Subject: AP1000 COL Standard Technical Report Submittal

Subject: AP1000 COL Standard Technical Report Submittal of Sensitive and Non-Sensitive Versions of APP-GW-GLR-033, Revision 0

# **AP1000 Standard Combined License Technical Report**

## **Spent Fuel Storage Racks Structural/Seismic Analysis**

Figure 9.1 2 (Sheet 1 of 2)

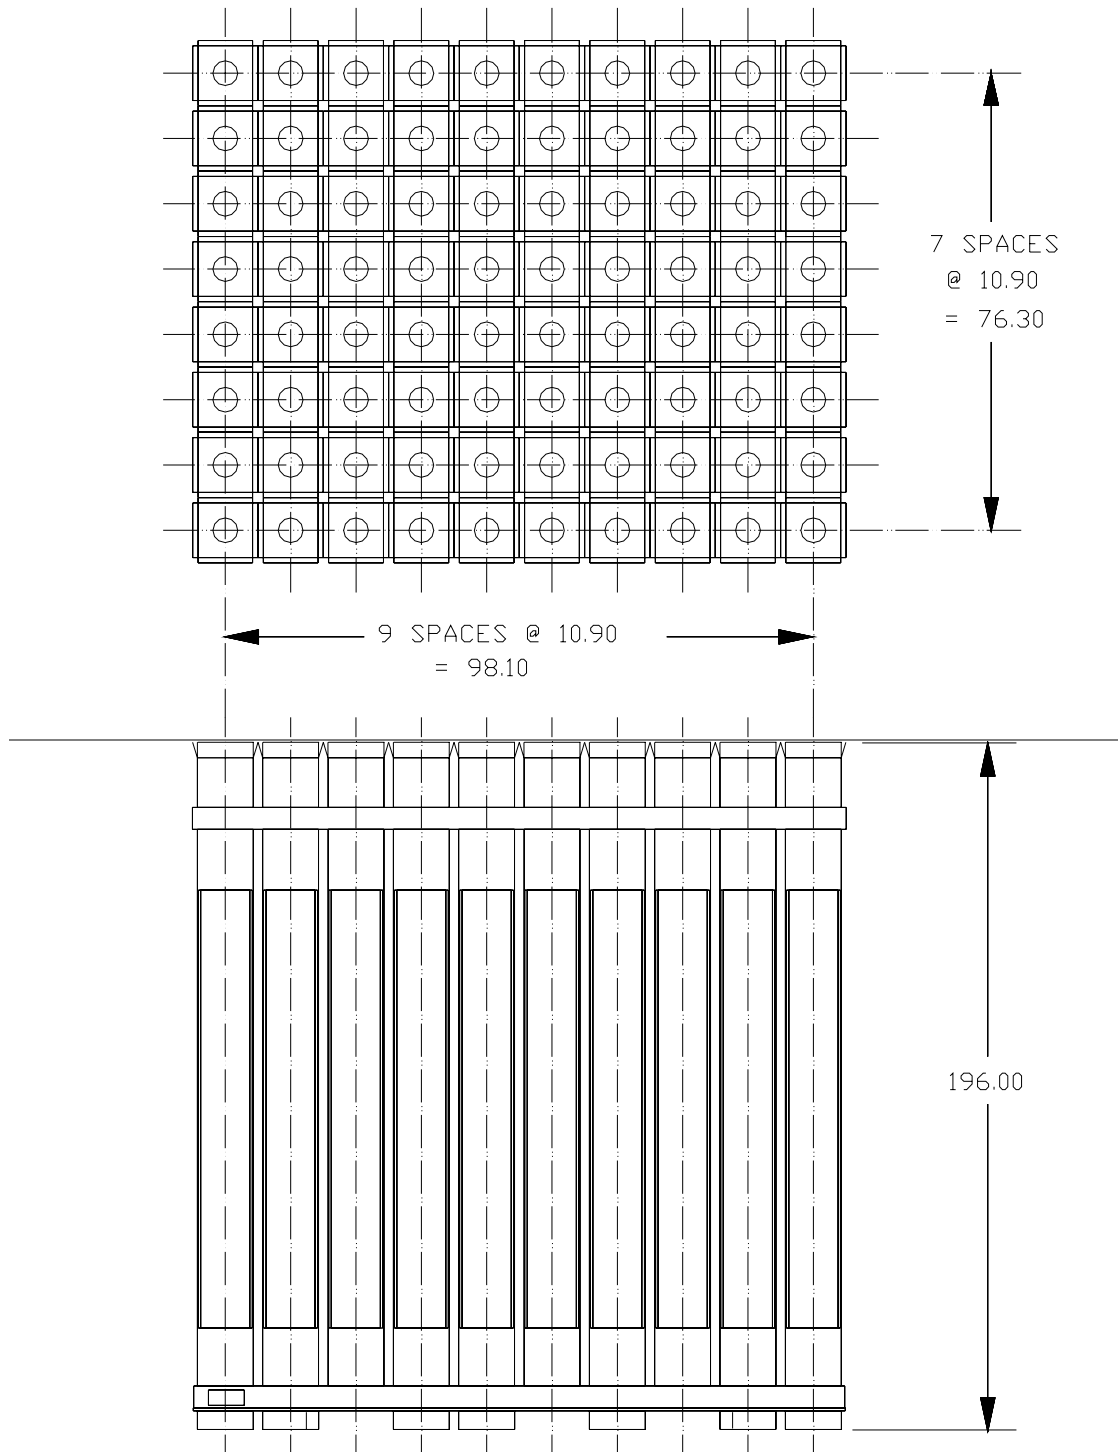
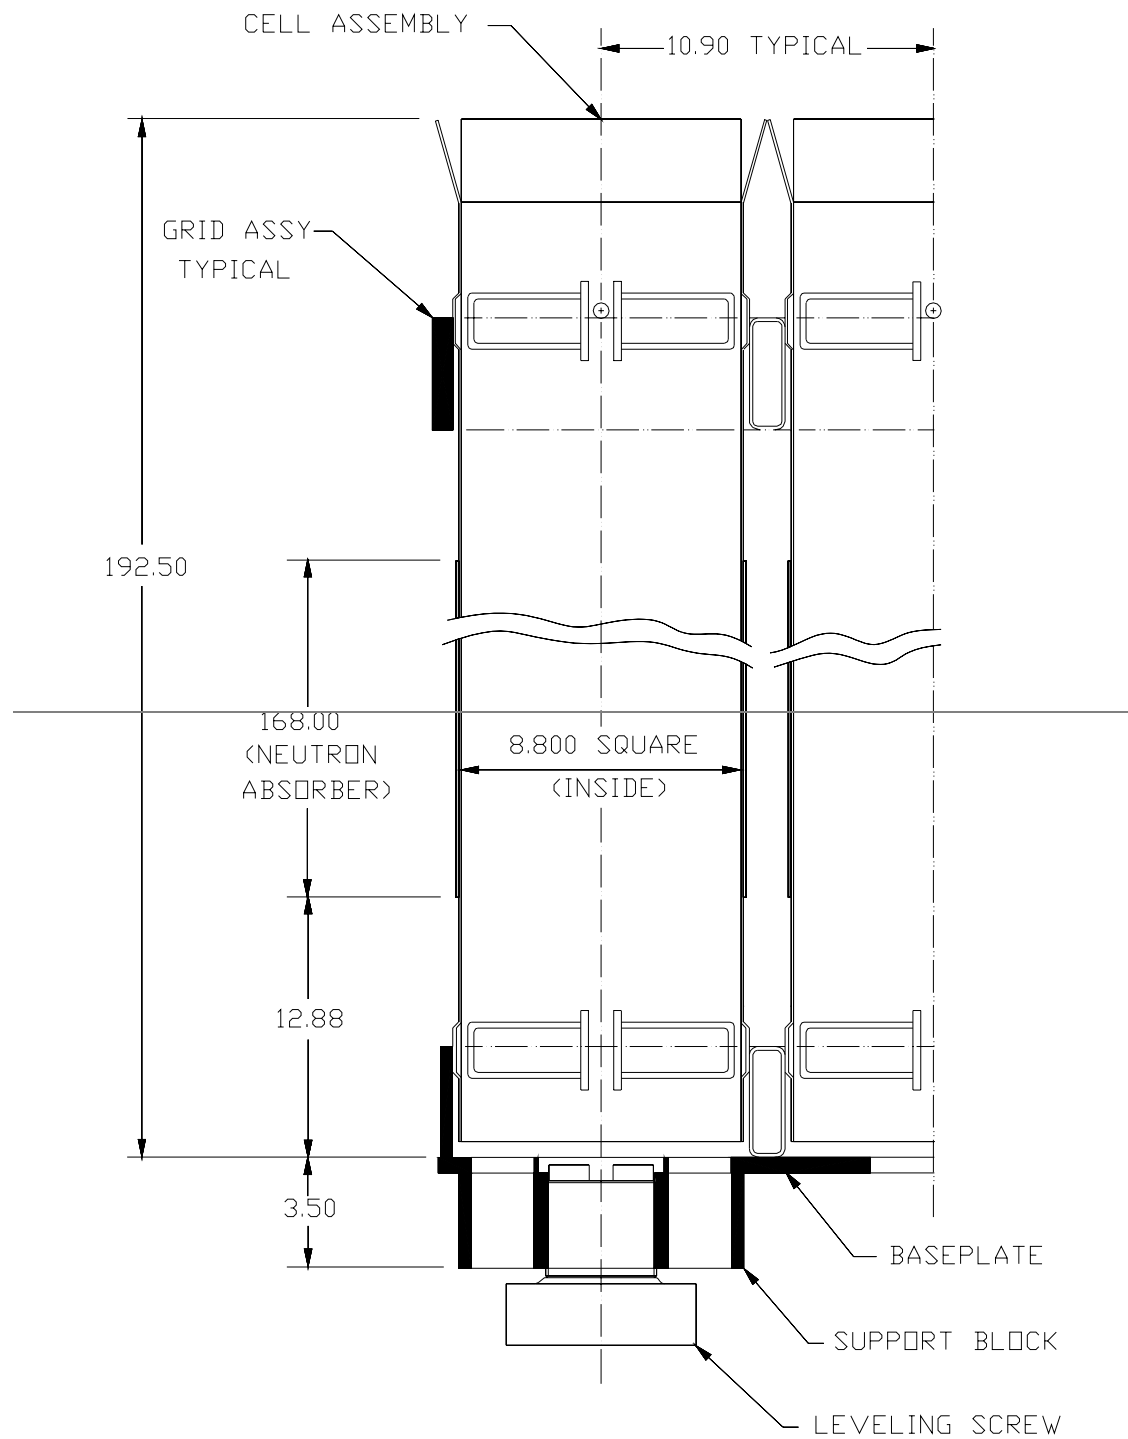
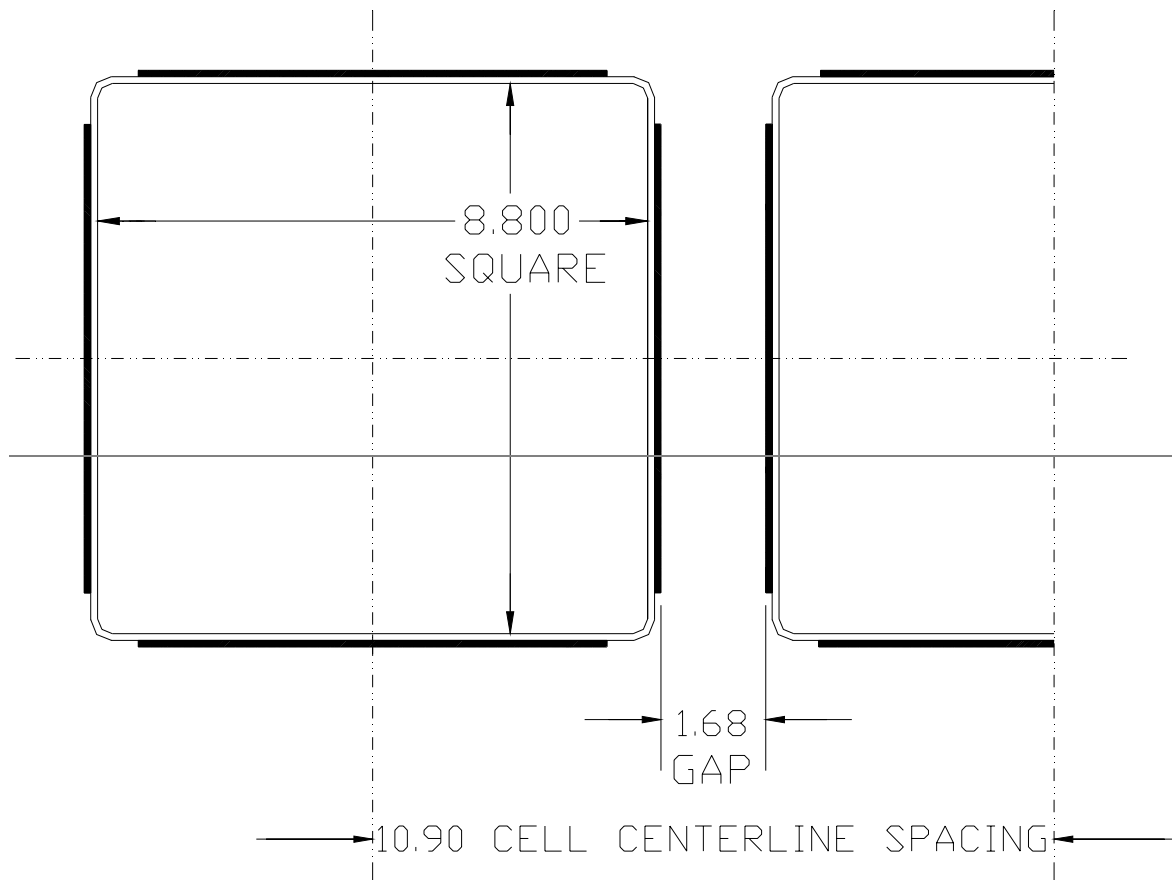
- Delete Figures 9.1-1 through 9.1-3 by indicating “Figures 9.1-1 through 9.1-3 not used.”
- Replace Figure 9.1-4 with a new Figure 9.1-4.
